PUBLIC INTEREST REVIEW FOR GROUND WATER APPLICATIONS

SUBJECT: Application G- 17799 Supersedes review of _____
Date of Review(s)

A. GENERAL INFORMATION: Applicant's Name: Bo Thorenfeldt County: Harney

A1. Applicant(s) seek(s) 14.667 cfs from 6 well(s) in the Malheur Lake Basin,
Harney Valley subbasin Quad Map: Carson Point

Application G-17799, Bo Thorenfeldt (Map #1)

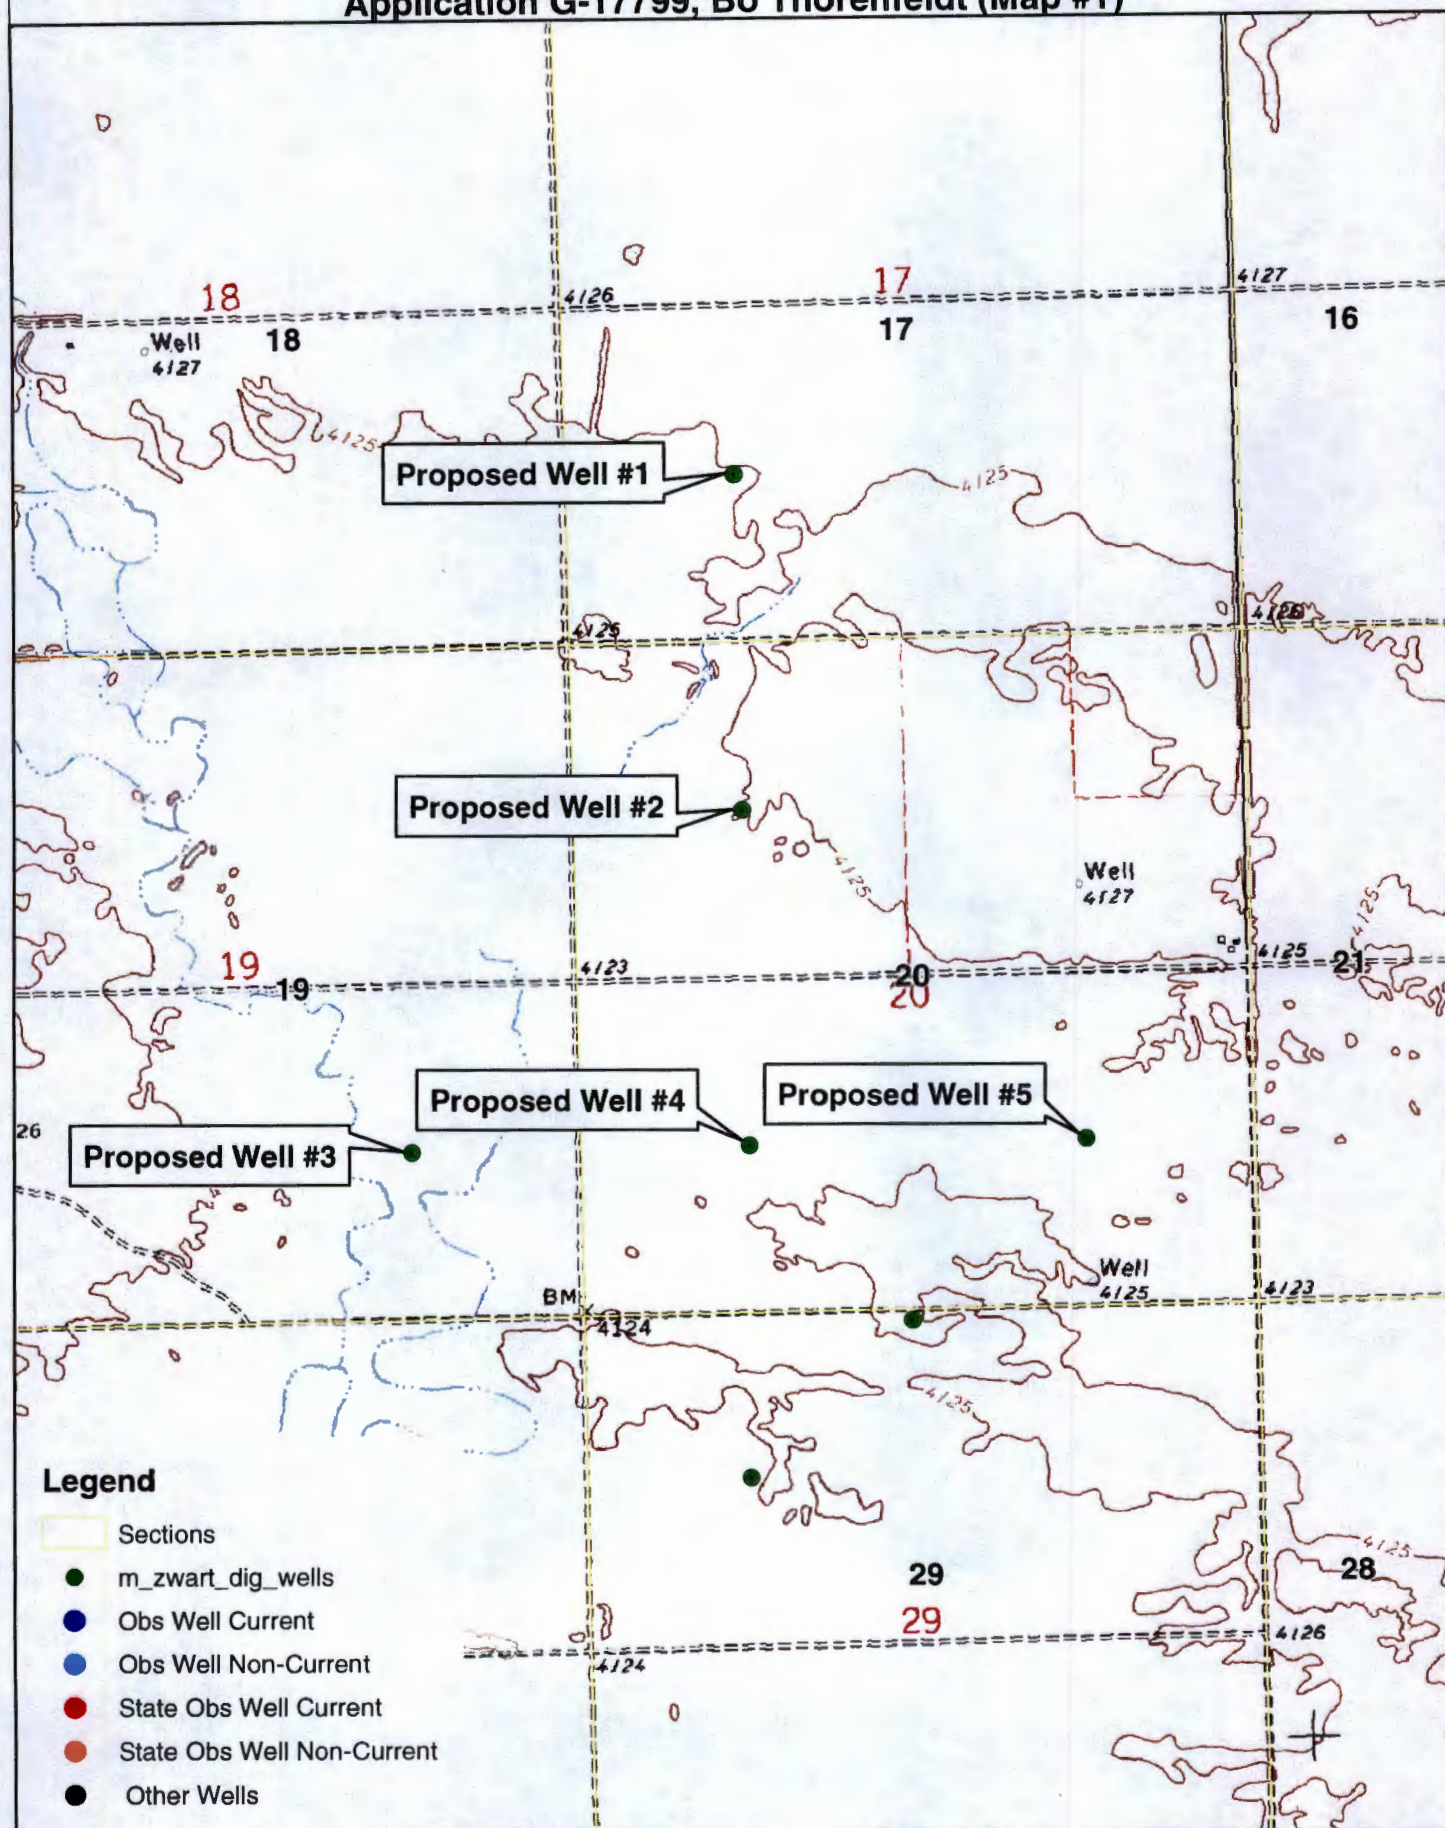
- B3. Ground water availability remarks: There are no current or non-current State Observation Wells nearby with long-term water-level records. There are also no other water-level data on file for the local area except for nearby well HARN 51275, which has been measured only a few times as part of a permit condition. However, water-level data being collected in the Weaver Springs area to the southwest and in the Crane area to the south have disclosed groundwater level declines in areas that have experienced significant development of groundwater for irrigation. The Crane area is noteworthy because it is a local example of over-appropriation of the groundwater resource and it has a similar climate, underlying geology and recharge as the area here. Review of local well logs and the November 2012 draft Harney Basin Groundwater Study indicate that the regional groundwater flow direction in this area is generally to the south toward Malheur and Harney lakes. Therefore, this area is likely upgradient of the Crane area. This is significant, given the documented water-level declines in that area and the fact that several existing groundwater rights in that area are yet to be developed. In addition, several other recent applications are pending in the area immediately surrounding these proposed wells. Thus, the water-level declines are likely to increase in time as these existing and pending rights are more fully developed. Issuance of a permit for the amounts proposed here will likely result in water-level declines at the proposed wells that would exceed the limits set forth in permit condition 7N, which is typically recommended. The use of the proposed wells would also likely result in water-level declines and possibly also substantial interference at nearby existing and proposed wells with senior rights.

Special Permit Condition: The permittee shall construct one minimum six-inch diameter observation well to penetrate the same aquifer as the production wells. The well shall meet the Department's minimum well construction standards and shall be cased and sealed to the same depth as the production wells. The well shall be constructed at a location approved by the Department for the purpose of instrumentation with continuous water-level monitoring equipment. The landowner or permittee shall provide access to Department staff to install and maintain the monitoring equipment. The well shall not be used for any other purpose while the Department is monitoring water levels. The well shall be completed prior to water use under the terms of any permit issued.
